PLANNING COMMISSION MEETING STAFF REPORT

NAME OF PROJECT: Daybell Garage Mixed Use Project – Restaurant and Residential Unit

AGENDA ITEM: Conditional Use Permit

Subject: Daybell Garage Conditional Use Permit Review

SITE PLAN
Scale: 1/8" = 1'-0"

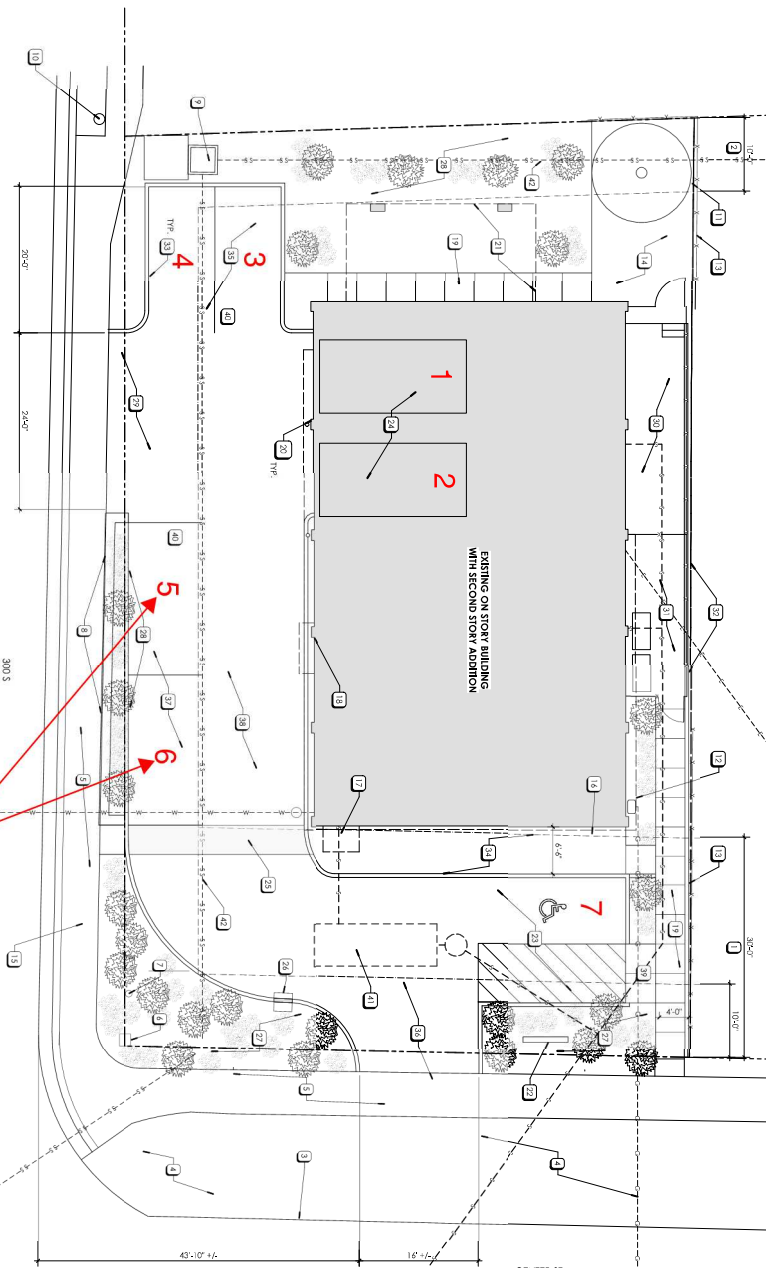
Solid Waste – The applicant is proposing the use of trash canisters that would be located along the north side of the building behind a fence. Care should be taken to ensure that the trash containers are kept within the fenced area. The property adjacent to where they would be located is zoned commercial and is mostly vacant. The owner will be required to pull the containers to the designated public street for trash pickup.

Parking/Vehicular Circulation/Drive-thru Window – Because the applicant is designing around an existing building on a relatively small parcel, a major obstacle encountered has been accommodating the various uses along with the vehicular parking and circulation requirements. The applicant would like to use a drive-thru window, but there currently is not adequate space to accommodate it along with the required parking and vehicular pass-through lane. The applicant is working with a neighboring property owner to see if they are able to lease property to help satisfy their required off-street parking. With city council approval, a business can relocate some required parking on a neighboring property. Because those arrangements are not in place, the applicant is proposing a phased approach to realizing the drive-thru window. The current proposal would use the drive aisle as a pass-through for vehicles and parallel parking. If the applicant can negotiate a lease allowing them to relocate some of their required parking to a neighboring property, and that arrangement is approved by the city council, they would then install the drive-thru window and move the pass-through lane to the south where the two parallel parking spots are. Staff is supportive of them installing a normal window in the spot where a future drive-thru window would be located, but we would recommend that no drive-thru window is installed until an off-site parking agreement is in place and the two parallel parking stalls are relocated

Currently, the site plan shows two stalls in the garage and five off-street parking stalls, which satisfies their obligation to provide seven off-street parking stalls.

If in the future the City Council approves a cross parking agreement, these parking spots may be relocated off-site, allowing for the use of a drive-thru window on the north side of the drive aisle and a vehicular pass through on the south side of the aisle.
